Revisions and Modifications for version 5:

D1200719-v5
High Stability, Low Noise
Laser Current Driver

Version 7:

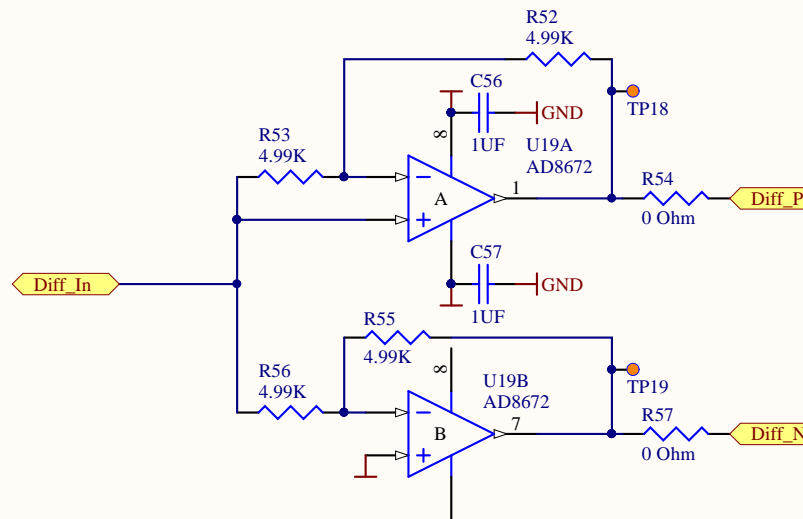
1. The input noise of U9 sets the sensing noise for the output of the slow path; replaced the OP27 with a lower noise LT1128.
2. Added protection circuit across pins 7 and 3 of the DB9 laser connector J2. The serial diodes D17, D18, D19, D20 limit the voltage drop to -4V.
3. The slow feedback path was displaying excess noise at the crossover frequency of the two feedback loops (M1 and Q2) in the slow path. In contrast, a single Power-MOSFET at location Q2 was found to be stable and sufficiently quiet.
4. Omitted M1.
5. The purpose of D16 is to protect M1, so it was omitted.
6. Changed R60 value to omit, as it serves no purpose without M1 installed.
7. Changed R22 to 0 Ohms and added R63=0Ohms to connect output of U9 to gate of Q2.
8. Omitted C35, as it was found to not be required with the power Mosfet installed.

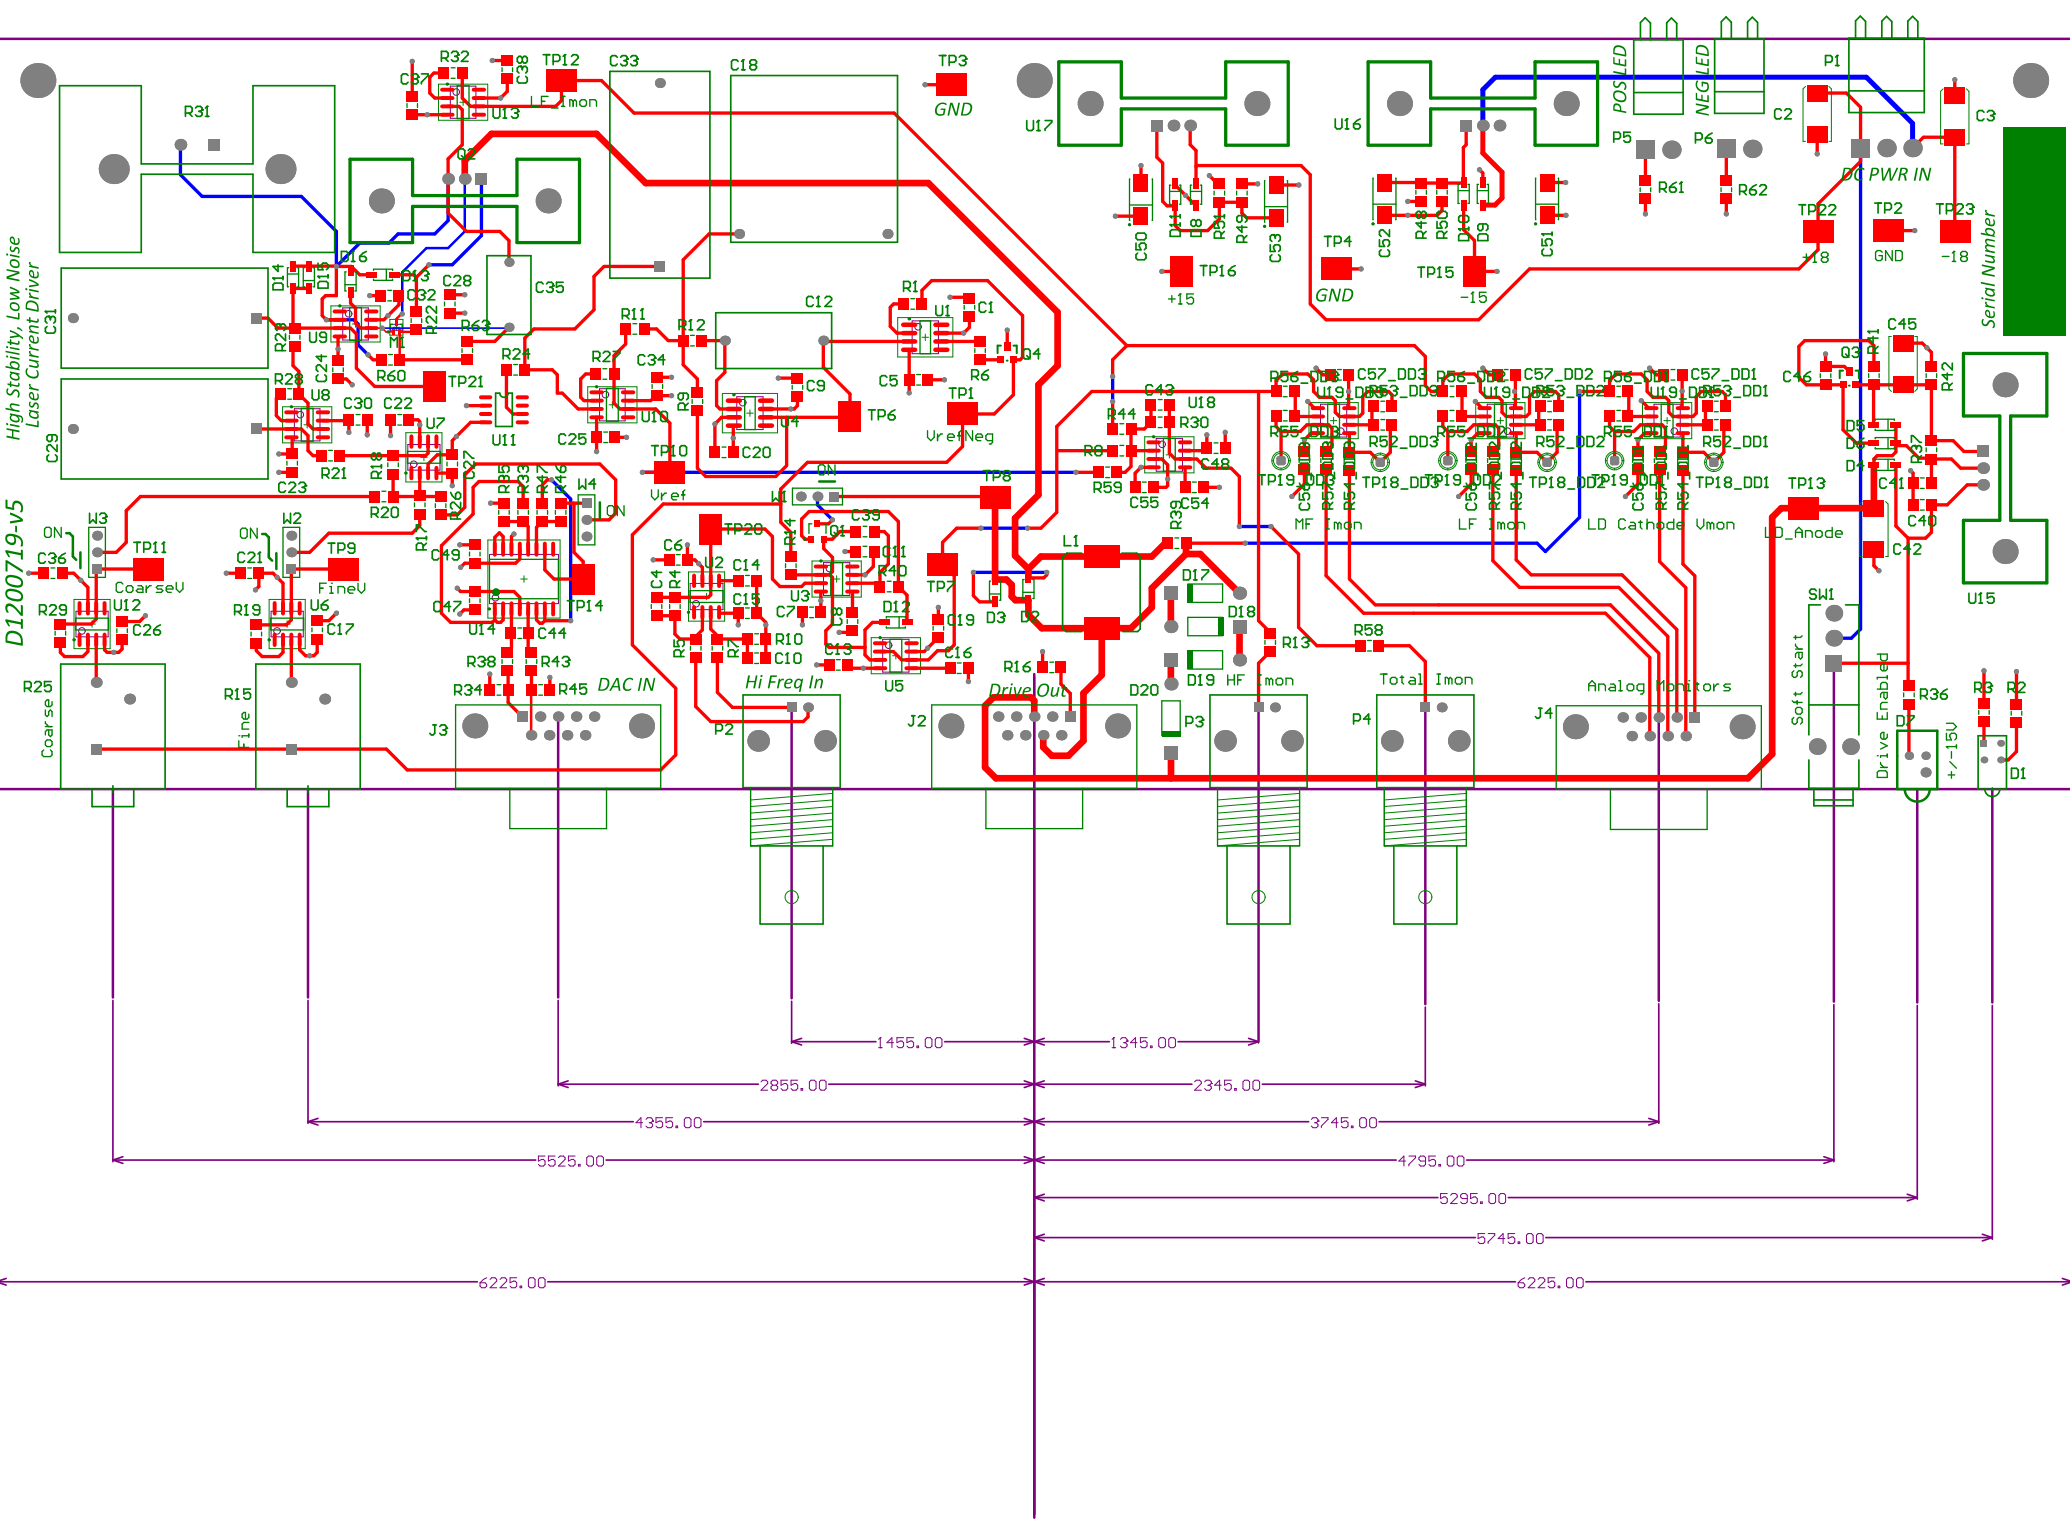
1. Used shorter heat sinks for regulators so it will fit in a 1U chassis.
2. Ensured voltage reference is a 10V part. The bill of materials had this as 5V.

3. R42 changed from 750 to 2.2k to provide about 15VDC regulated power for the laser driver.
4. Added a 490k resistor to pick up the Vref connection, thus improving the accuracy of the current monitor.

5. Put a FET back onto the base drive of the main current modulator to eliminate base current error.
6. Changed R44 to 10k to make current readout more reasonable.

7. Diode protection of U9 by back-to-back diodes across positive and negative inputs.
8. Change C14 from 68pF to 27pF for less compensation of the AD829.

9. Add provision to drive the chassis rear panel LEDs for +/- 15VDC.
10. Change C39 to 100pF.
11. Change C35 to from 10nF to 1uF; should update footprint to leaded plastic capacitor.

12. Q1 E-B Backwards on PCB.
13. Change R31 from 100 to 50 ohms to increase the current range.
14. Added protection diode to Q1 base (D12).
